RE: DA2020/0458 Submission
4 Notting Lane Cottage Point

**RE: DA2020/0458 Submission
4 Notting Lane Cottage Point
Objection**

Appendix 1

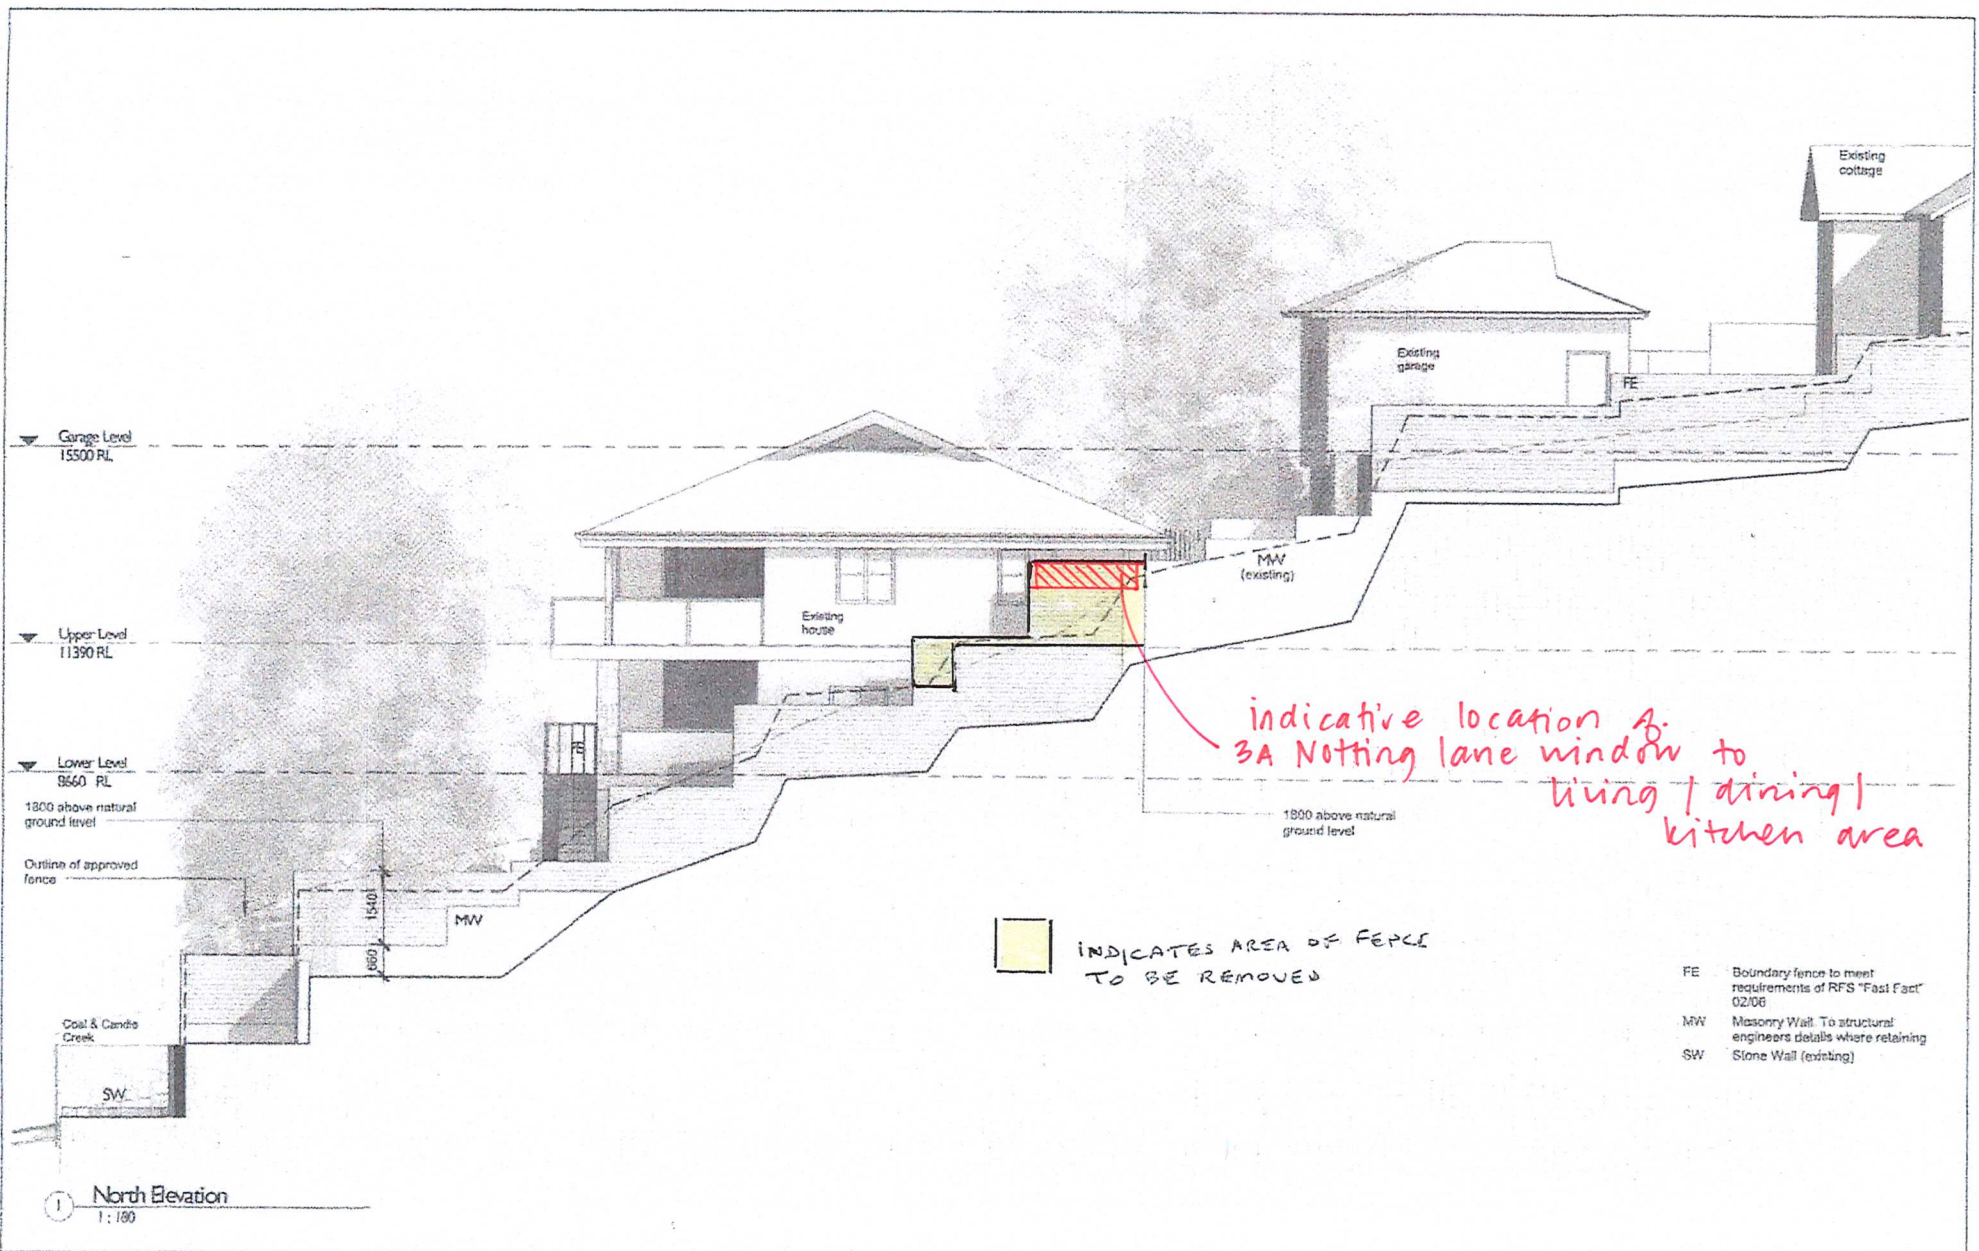
Privacy and amenity - the proposed route of the inclinator extends the full length of our house.

The passengers awaiting boarding of the inclinator at proposed Station 2 and those on the inclinator will have direct visibility into our property through our south facing window as they wait/transverse on the inclinator, regardless of the screen to the North. (See Appendix 1)

Appendix 2

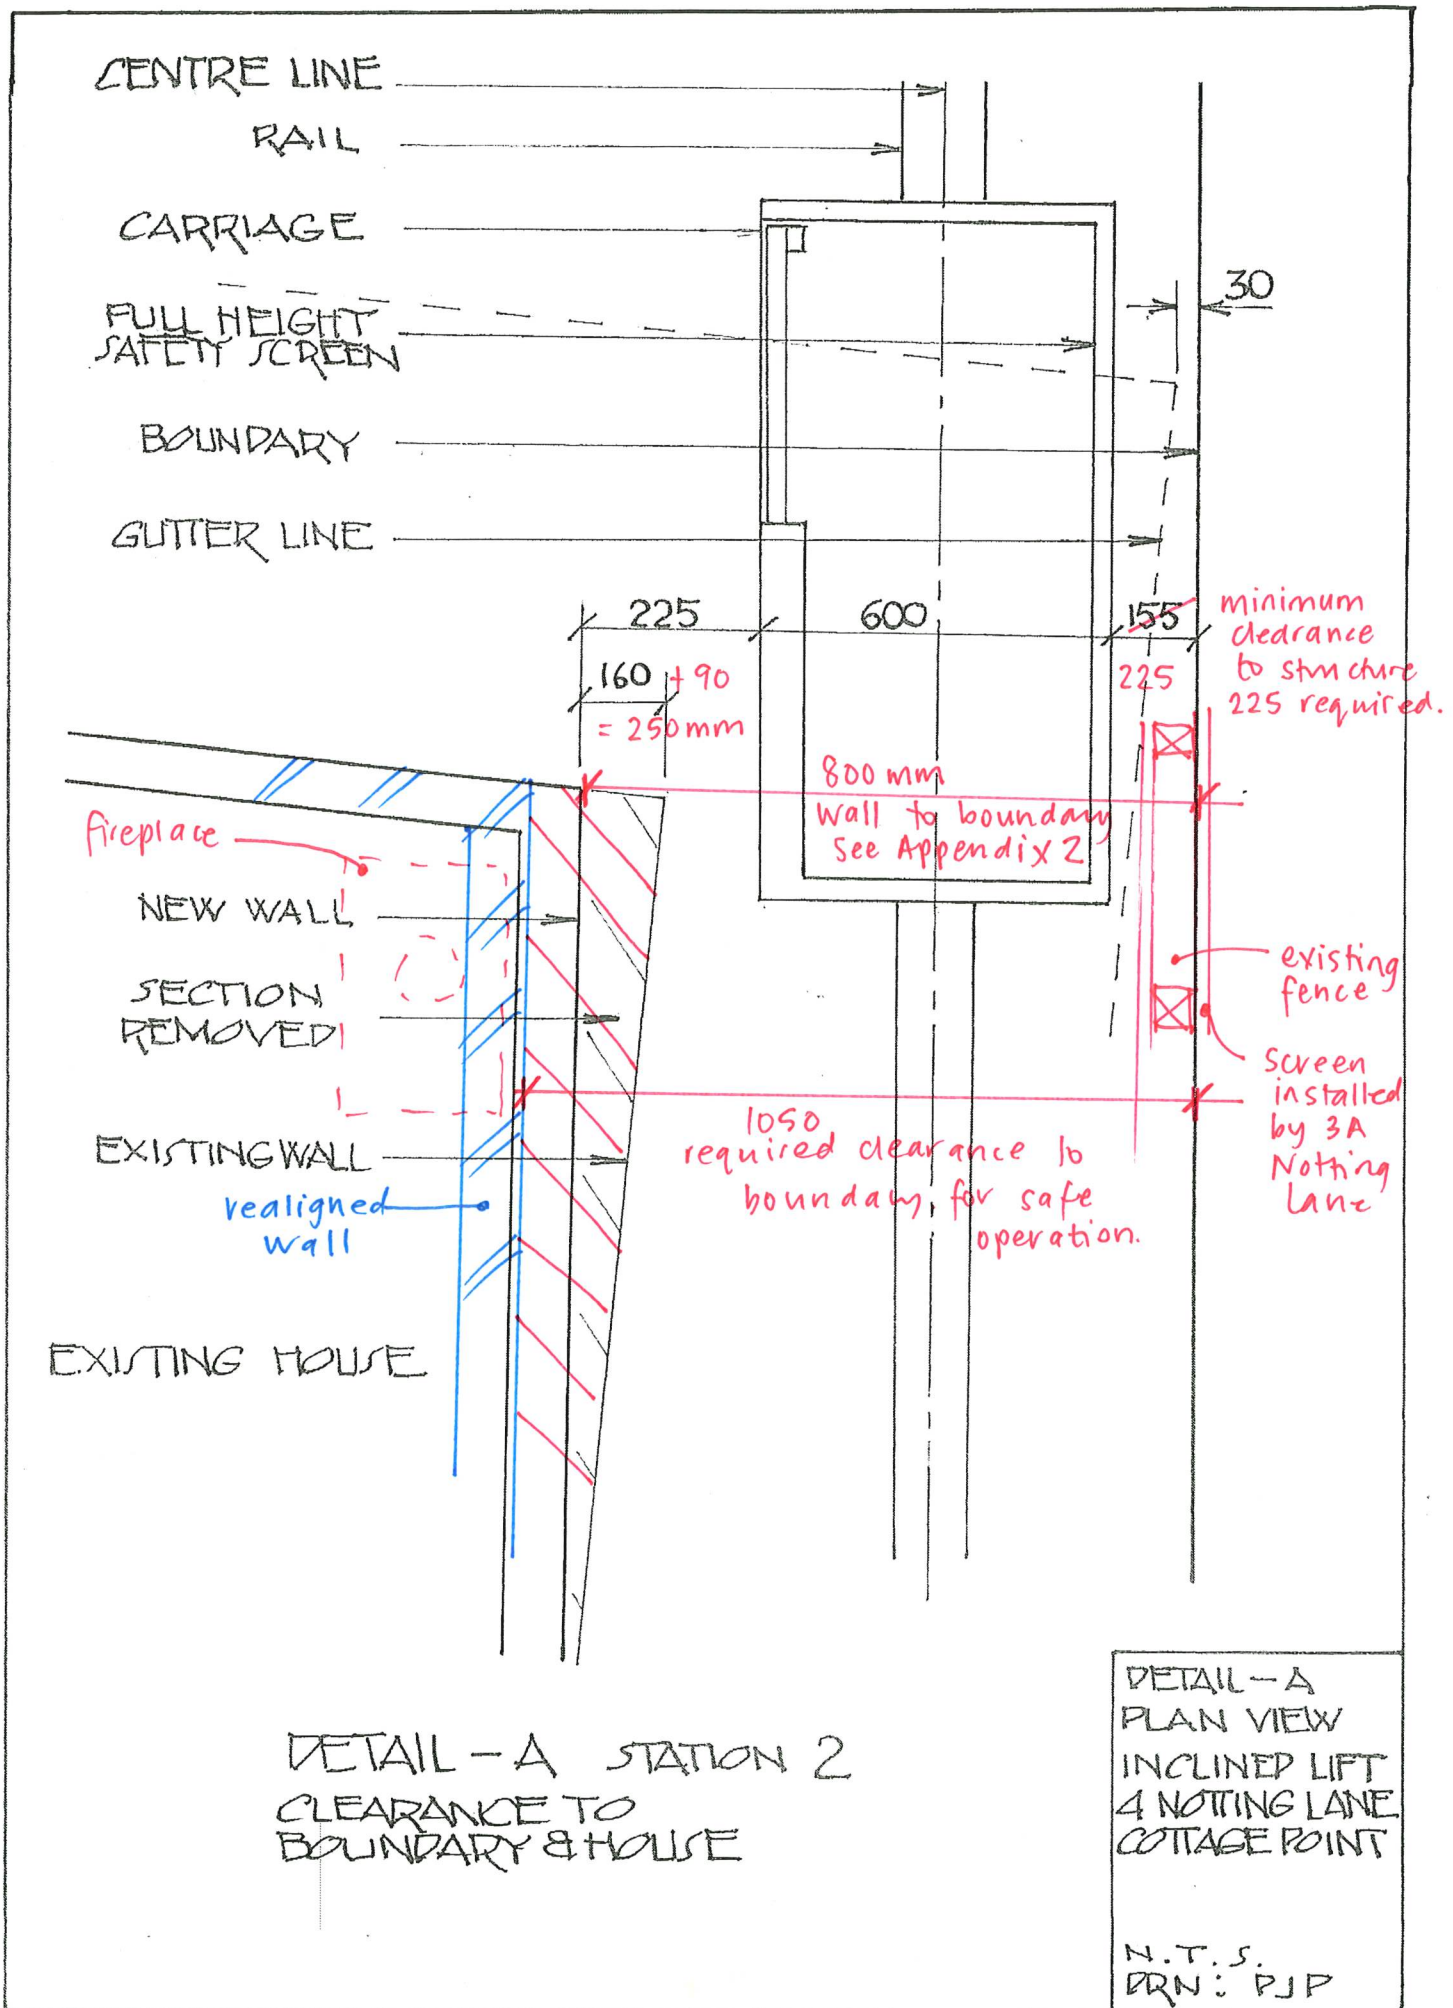
Clearance to Boundary - the applicant has stated that his boundary is 820mm at the narrowest point from the sidewall of the house to the boundary.

The Byrne Survey, provided and undertaken by Council at the time of the sale of Lot 3 Notting Lane, stipulates this dimension to be 800mm. (see Appendix 2)
